# **Blarghour 132 kV Wind Farm Connection**

## **Report on Consultation (Routeing Stage)**

**June 2026**

**LT000315**

**Figure 2.1: Route Options**  
**Blarghour 132 kV Wind Farm Connection Report on Consultation (Routeing Stage)**

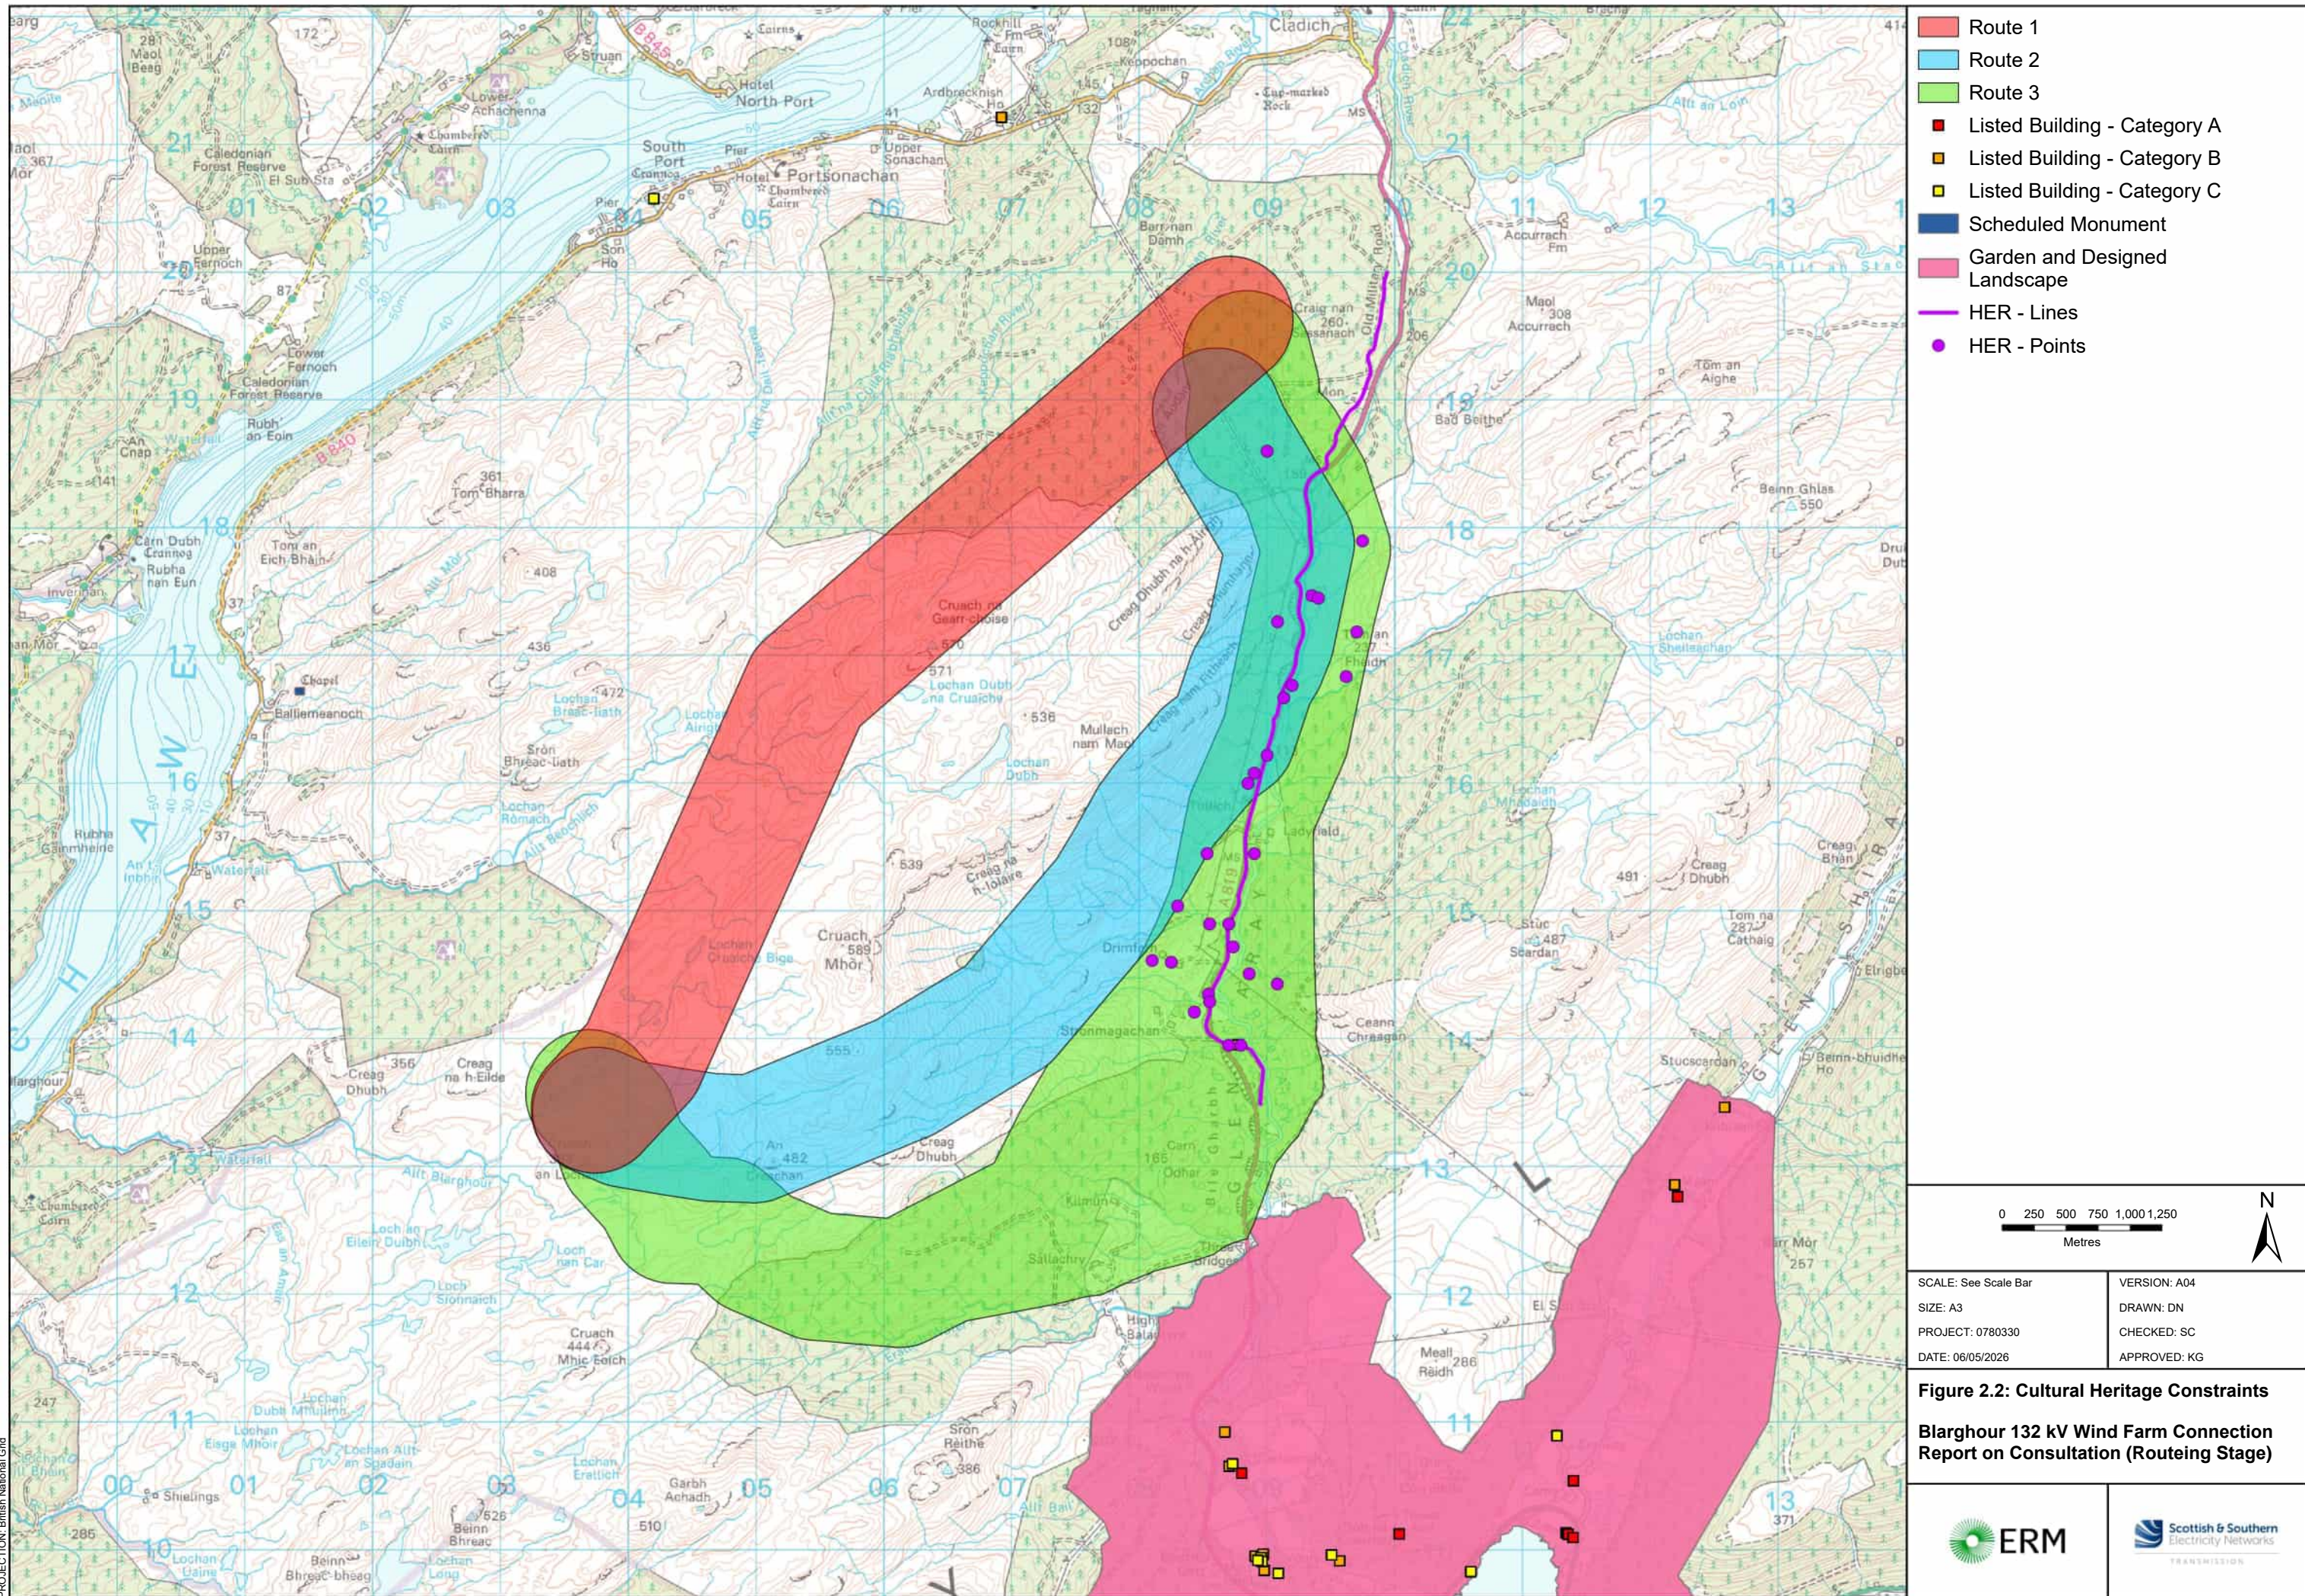
NatureScot	<p>NatureScot agree that, of the three route options, Route 3 is the most appropriate option. They noted that the explanation provided clearly identifies potential risks to nature and that Route 3 lies out with the buffer distance of the nearest known golden eagle nest, minimises impacts on key habitats including priority peatland, and</p>	<p>SSEN welcomes NatureScot's support for Route 3 as the most appropriate option and acknowledges their advice regarding reduced risks to golden eagle and key habitats. Further</p>

Stakeholder	Summary of Feedback	Response by SSEN Transmission
	<p>partially follows the Blarghour Wind Farm access track, thereby reducing potential disturbance to surrounding habitats and species. NatureScot advised that Route 2 could cause significant disturbance to a nearby golden eagle nest, with the potential risk of nest abandonment.</p>	<p>refinement of the alignment within the Route 3 will continue as the project progresses, with the aim of minimising disturbance to surrounding habitats and species.</p>
	<p><b>Designated Sites and Golden Eagle</b></p> <p>NatureScot confirmed that their previous advice (February and August 2023) remains relevant. Given the proximity of the Proposal to the Glen Etive and Glen Fyne Special Protection Area (SPA), they advised that the EIA Report should include a robust assessment of potential effects on golden eagle, both in relation to the SPA and the wider NHZ 14 population, including cumulative effects.</p>	<p>SSEN acknowledges that a robust assessment of potential effects on the Glen Etive and Glen Fyne SPA and the wider NHZ 14 golden eagle population, including cumulative effects, will be undertaken to inform the consenting stage, supported by a Habitats Regulations Appraisal as required. The EIA Report will include up to date survey data in addition to a wealth of desk based resources including findings from surrounding EIA developments and satellite tag data for local birds.</p>
